With reference to the planning application DC/25/2080 Leith View RH13 9HA.

SECTION OF "CHEVROE" BUNGALOW FRONT TO REAR WHICH IS THE SAME AS "LEITH VIEW"
MEASURED 21/12/2025

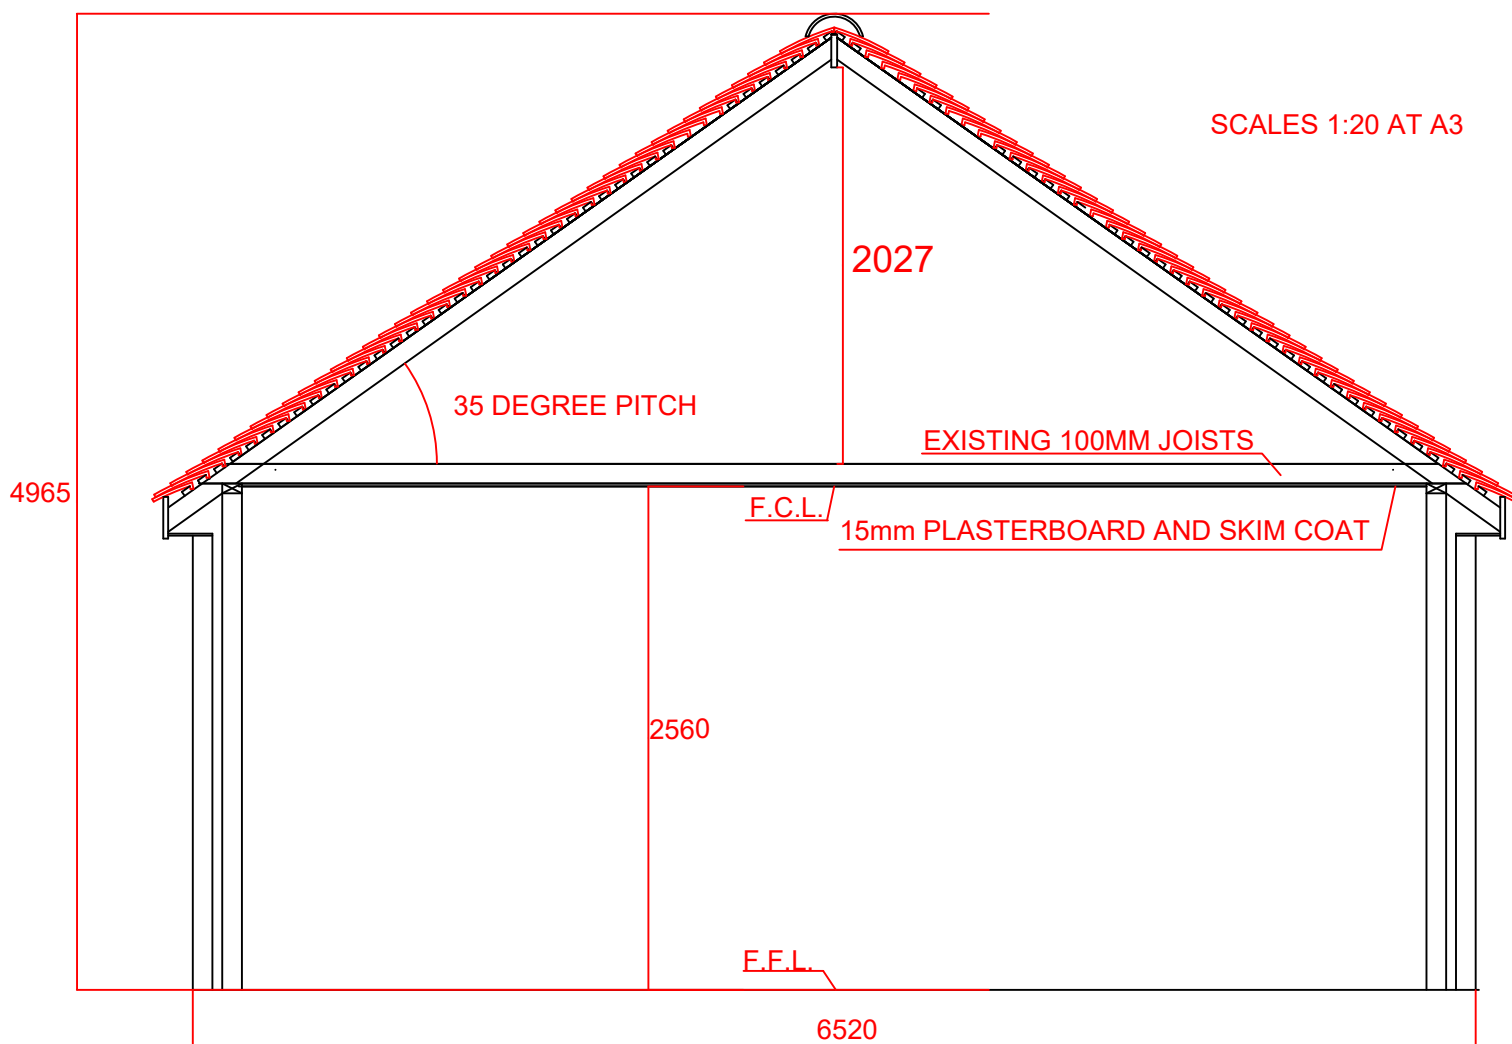
The proposed section drawing (D007) on the application shows a finished floor to ridge height of 5.4m. This is incorrect; all 4 properties were built to the same foot print, with a finished floor to ridge height of less than 5m (4965mm).

I have attached an accurate section drawing of one of the bungalow roofs. This drawing and dimensions have been checked by the architect.

The architect has calculated that the existing section would result in a finished ceiling height of only 1850mm, when allowing for structural design and insulation to meet building regulations.

Therefore if a habitable room were to be constructed in the roof the ridge height would need to be increased which is not allowed under G.P.D.O. and a planning application would be required in the usual way, it would impact upon the street scene and neighbouring amenities such as lose of light, privacy and outlook.
